**Bradley Villa, Huddersfield
A641 Bradford Road Site Access Junction and Shepherds
Thorn Lane Ped/Cycle Access**

Response Report to Road Safety Audit Stage 1

July 2022 (Final)

Appendix C Optima drawing 19154/GA/01 Revision H

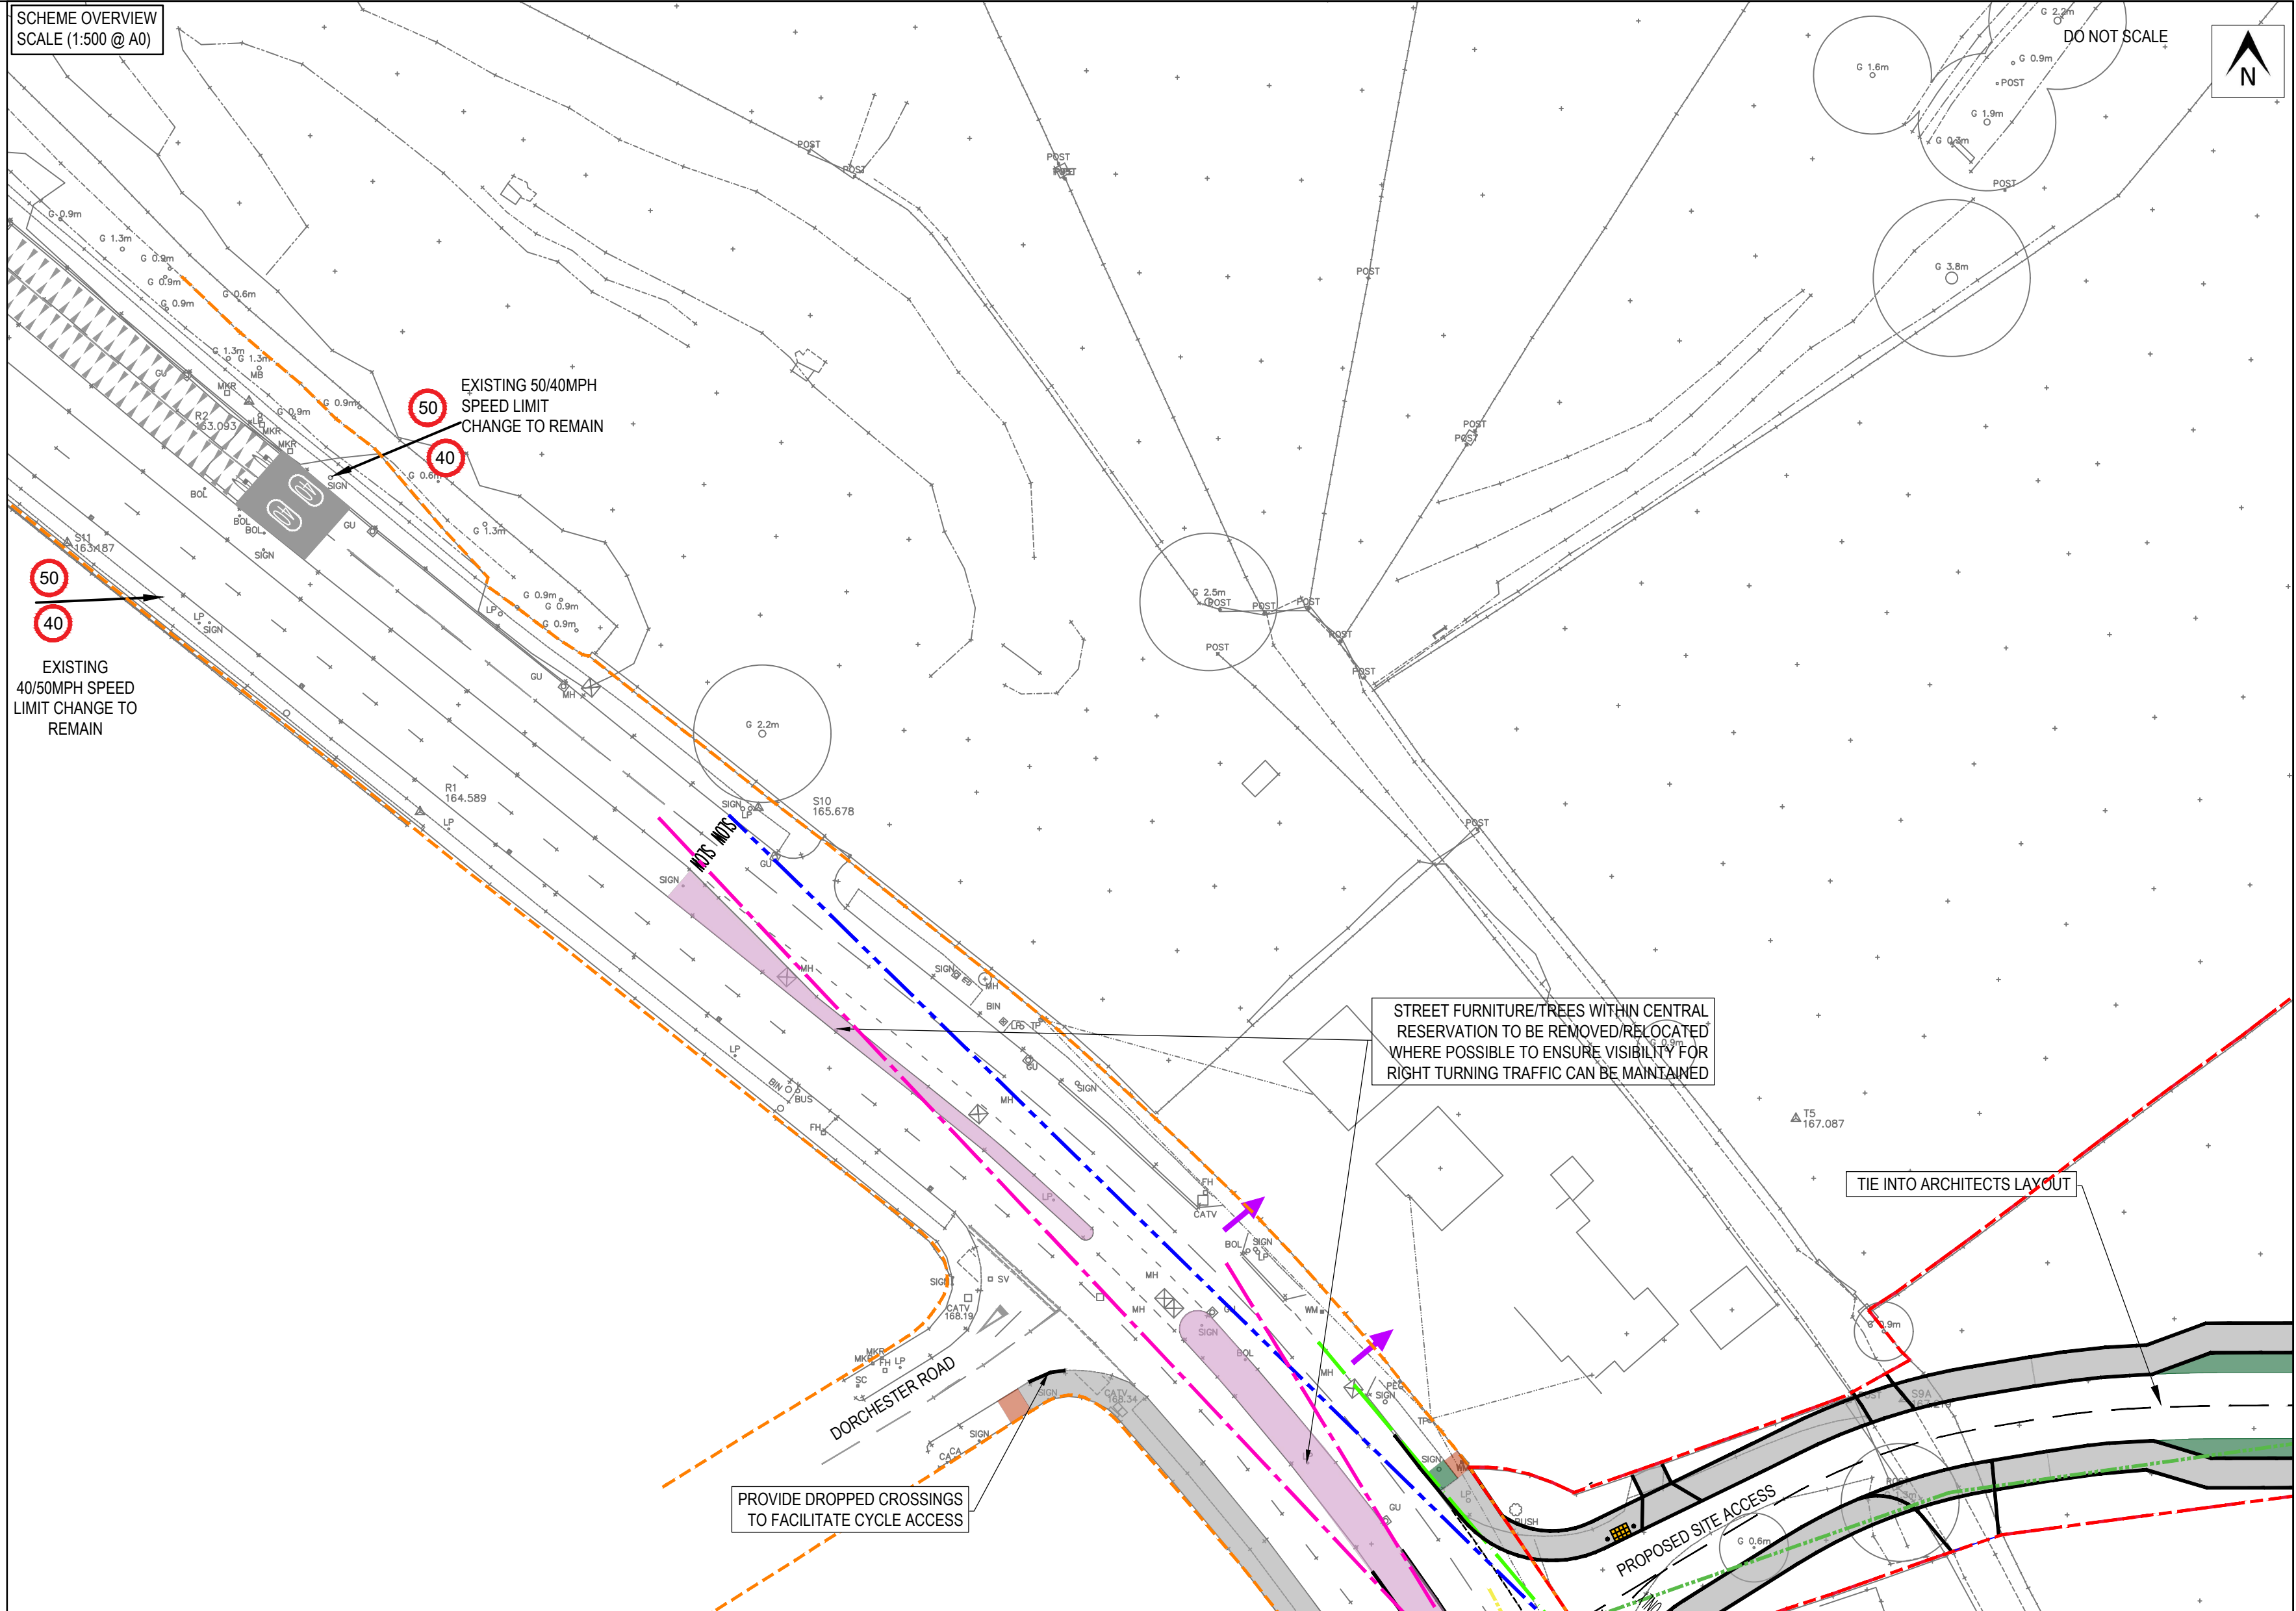
3.1.1 Problem: Central Island at priority junction may encourage right turns

The proposed drawing shows the give-way central island and central reserve along A641 Bradford Road. The arrangement may encourage (and physically still allow) drivers exiting the site to illegally turn right through the adjacent right-turn lane in order to avoid having to route southbound towards the Bradley Bar Roundabout and back north again. This will result in vehicle conflict and collisions.

It is recommended that the designs of the proposed site access junction give-way central island and A641 Bradley Road central reservation are amended to make the aforementioned dangerous manoeuvre as difficult as possible.

RSA Problem	RSA Recommendation	Design Organisation Response	Overseeing Organisation Response	Agreed RSA Action
3.1.1 Problem: Central Island at priority junction may encourage right turns Location – Centre of proposed site access / A641 priority junction. Summary – Proposed arrangement of give-way central island and central reservation may encourage vehicles to turn right through the right-turn lane. Detail – The proposed drawing shows the give-way central island and central reserve along A641 Bradford Road. The arrangement may encourage (and physically still allow) drivers exiting the site to illegally turn right through the adjacent right-turn lane in order to avoid having to route southbound towards the Bradley Bar Roundabout and back north again. This will result in vehicle conflict and collisions.	It is recommended that the designs of the proposed site access junction give-way central island and A641 Bradley Road central reservation are amended to make the aforementioned dangerous manoeuvre as difficult as possible.	The RSA recommendation is noted, and amendments have been made to the central reserve as shown on the drawing attached at Appendix C. The vehicle tracking drawing contained at Appendix E has also been updated to reflect the changes made.	The original layout already discourages right turn movements from the site access, through the provision of a deflection island on the minor arm, an extended central island adjacent to the right turn lane and the provision of the left turn only sign. Whilst the suggested extension of the central island would further discourage right turns from the site access, it also restricts the right turn movement into the access, which would be extremely constrained for large vehicles and this could result in overrunning of the islands. Therefore, the suggested alteration is not accepted. Due to vehicle swept path requirements on the minor arm, it does not appear possible to increase the size of the deflection island further as an alternative option. Therefore, it is instead suggested that additional left turn only text and arrow road markings are provided on the site access exit to reinforce the turning restriction at the junction.	Alterations to the design to make the right turn out of the Site access 'as difficult as possible' is not accepted. The layout already discourages right turning traffic out of the Site access and any extensions to kerb lines would be problematic for large vehicles manoeuvring into and out of the Site access. The agreed action is to provide additional left turn only text and arrow markings on the Site access to reinforce the turning restriction at the junction – as shown on the drawing attached at Appendix C.

Appendix D Speed Survey Information

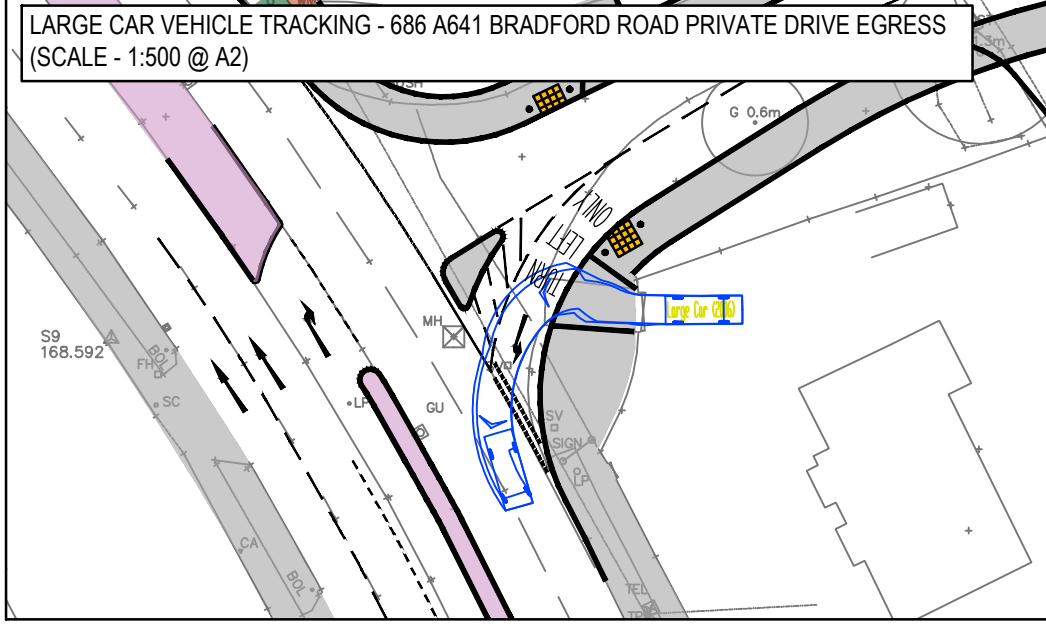
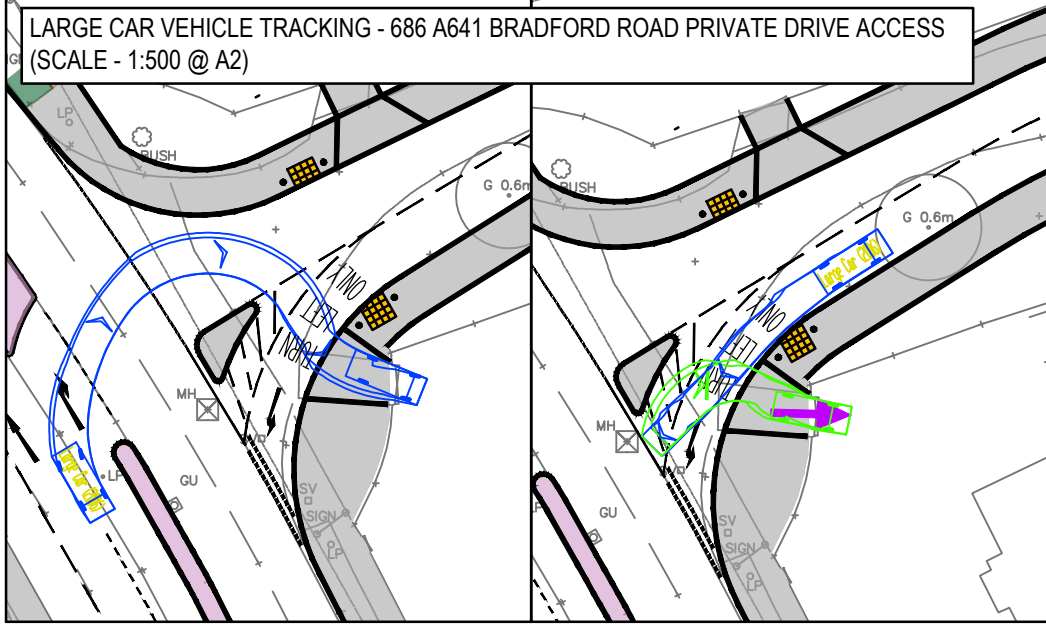
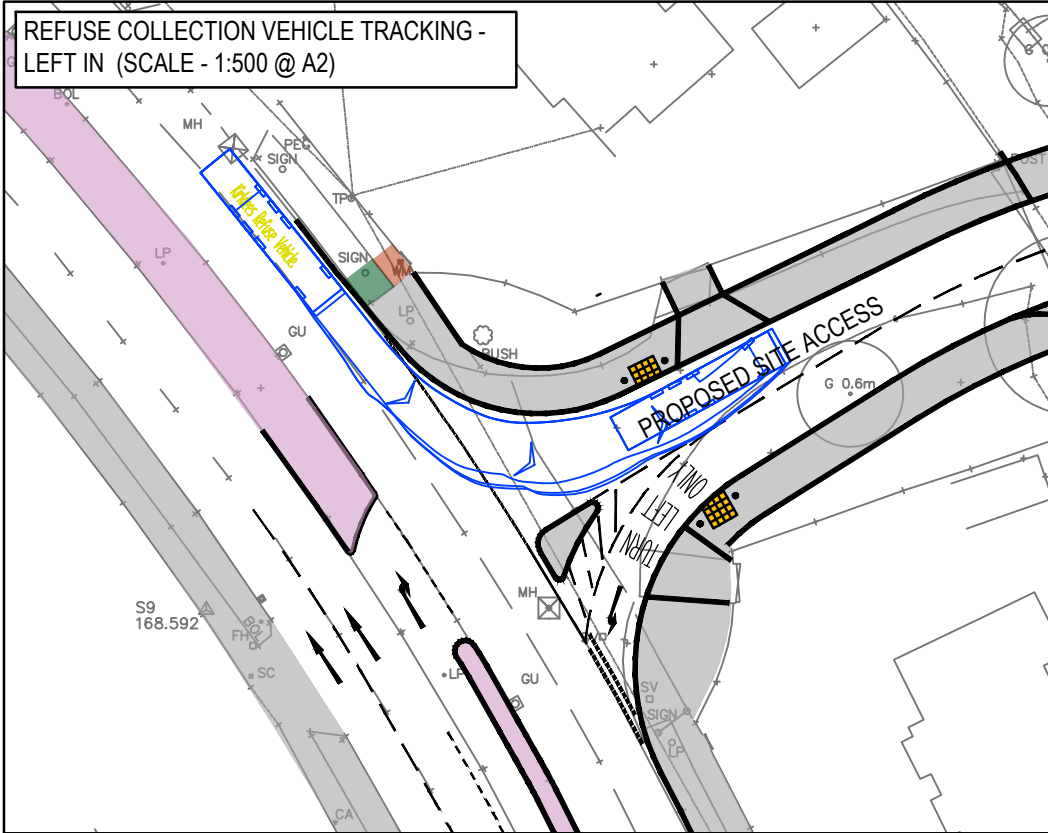
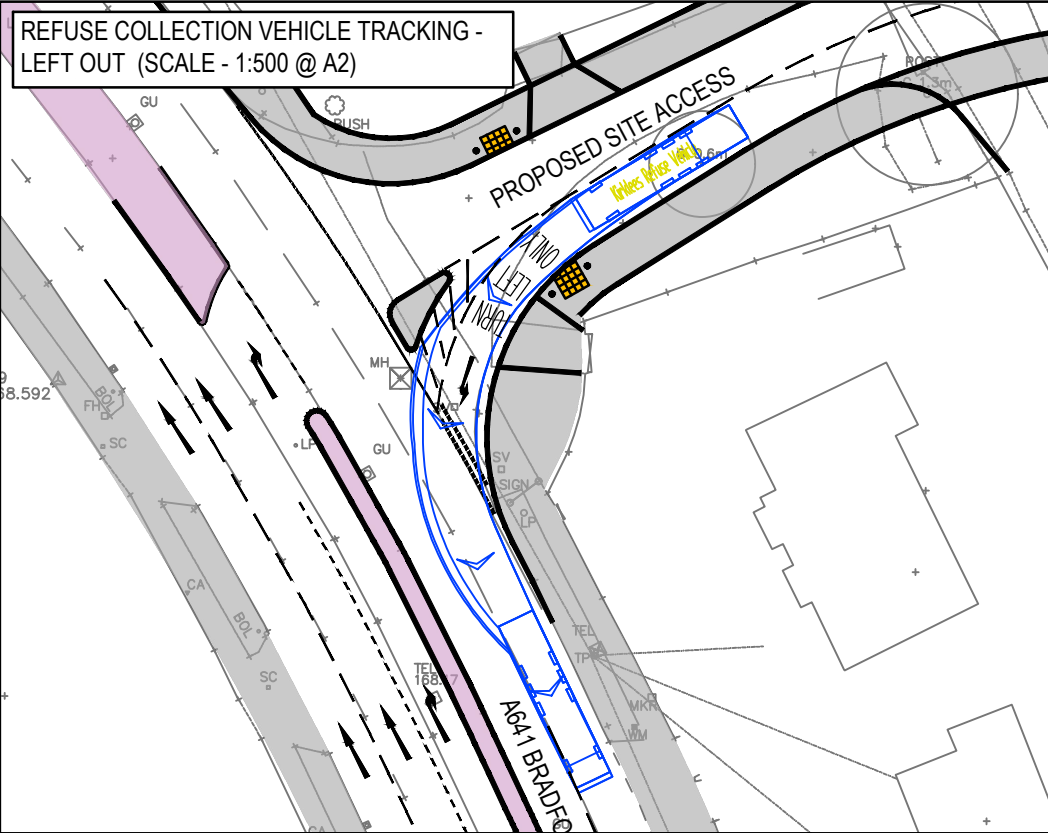
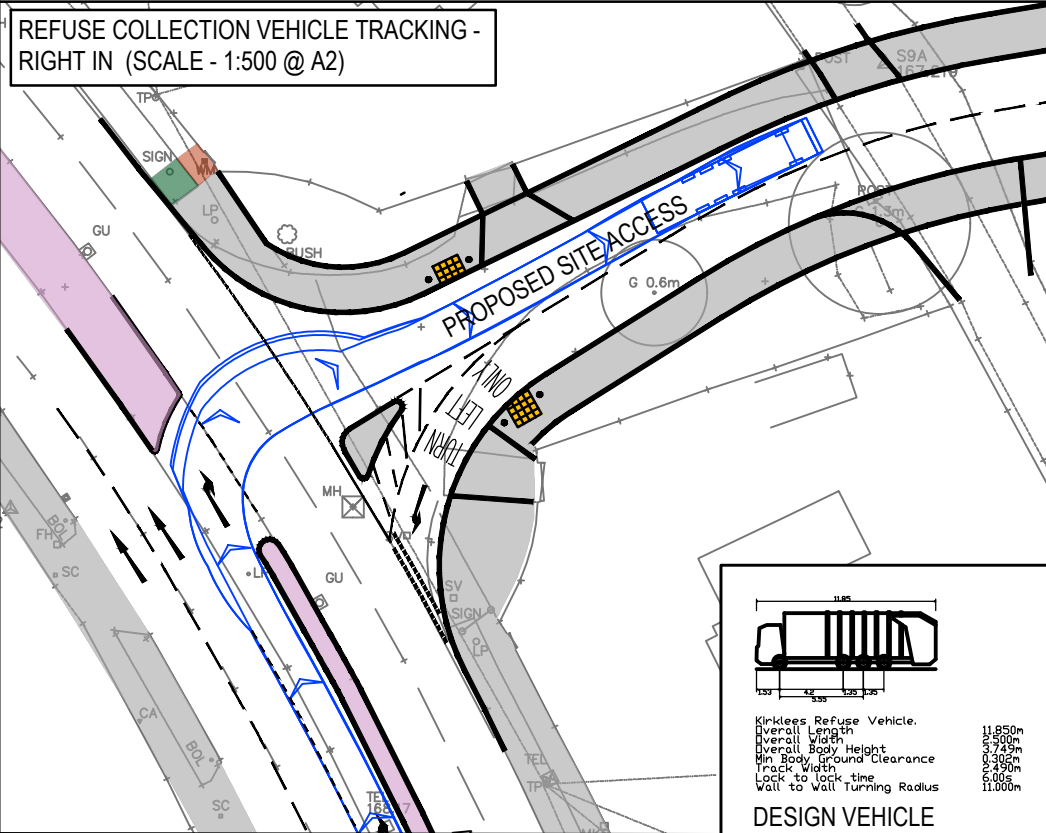
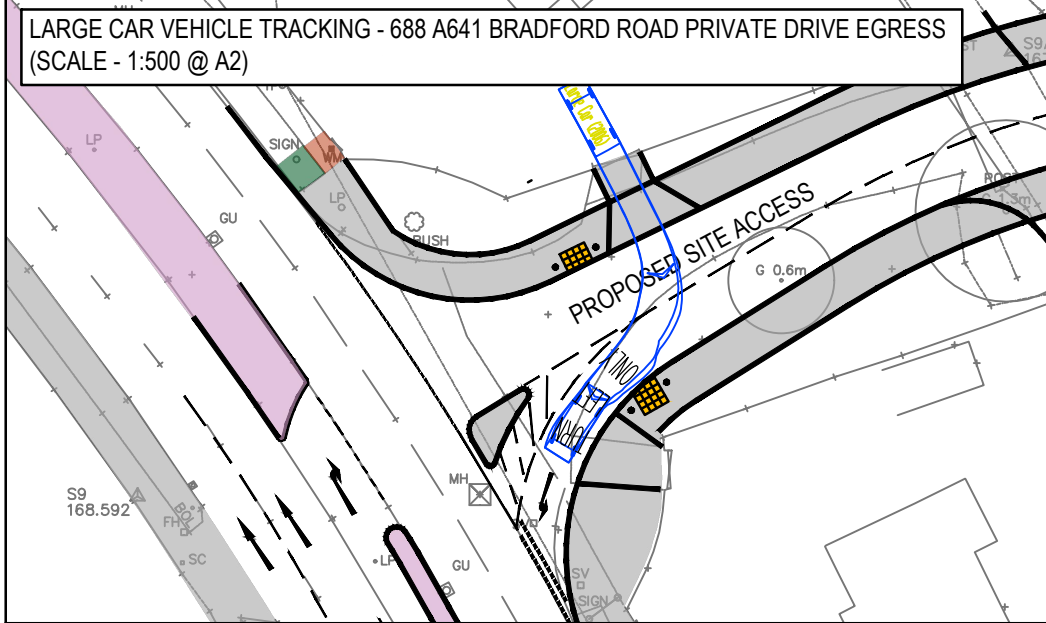
A visibility splay assessment should be carried out (potentially including a speed survey) to establish if adequate visibility is provided.

RSA Problem	RSA Recommendation	Design Organisation Response	Overseeing Organisation Response	Agreed RSA Action
			- Toucan crossing relocated from sightline; - Verge in central reservation either side of Dorchester Road junction that is within the visibility envelope to be replaced by hard surfacing; - Street furniture/trees in central reservation either side of Dorchester Road junction that is within the visibility envelope to be removed/relocated where possible (e.g. excluding any statutory signage etc that may be necessary). - Warning signage and SLOW road markings to be provided on southbound approach (e.g. replacement of the bend ahead sign with junction on bend ahead sign). - Vertical alignment of right turn lane carriageway designed to maximum available visibility.	markings have been shown on the southbound approach. All of the above measures will assist in maximising the available visibility for right turning vehicles as part of the detailed design process.
